ARKANSAS POWER & LIGHT COMPANY  
POST OFFICE BOX 551 LITTLE ROCK, ARKANSAS 72203 (501) 371-4000

2CAN068105

Subject: Arkansas Nuclear One - Unit 2  
Docket No. 50-368  
License No. NPF-6  
NRC Request for Information on  
Applicability of Existing Cycle 2  
Physics Reload Analysis to  
Reconstituted Fuel Assemblies  
(File: 2-1510)

FIGURE 1. ARB045

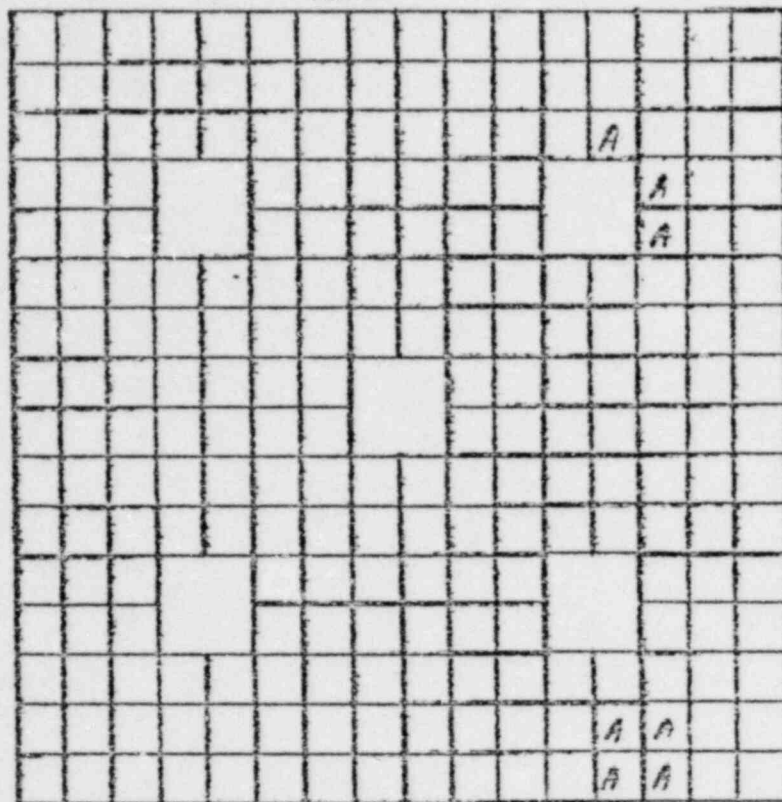
In response to a verbal question from your staff as to the location of reconstituted assemblies in the Cycle 2 core and whether the existing Cycle 2 Physics Reload Analysis bounds the reconstituted assemblies, the following information is provided.

The five bundles reconstituted and reinserted in the core for Cycle 2 were configured as shown in Figures 1 through 5. Figure 6 shows their core location in Cycle 2. The effect of this reconstitution on the core power distribution in Cycle 2 has been examined by performing a full core 20 PDQ calculation at beginning-of-life with the repaired bundles modelled explicitly. This calculation showed an increase in the maximum one pin-peak for the core of less than 1% from the nominal design. However, due to the number of pin replacements in assembly AKC308, a local power depression occurs in and around this assembly. The maximum reduction in assembly power is approximately 7% located in assembly AKC308.

COLSS and CECOR, using the incore detector system, will accurately measure the local and core wide power effects caused by the pin replacements. The net effect on the core power distribution is minimal and within the basis of the reload safety analysis and plant operating limits for Cycle 2.
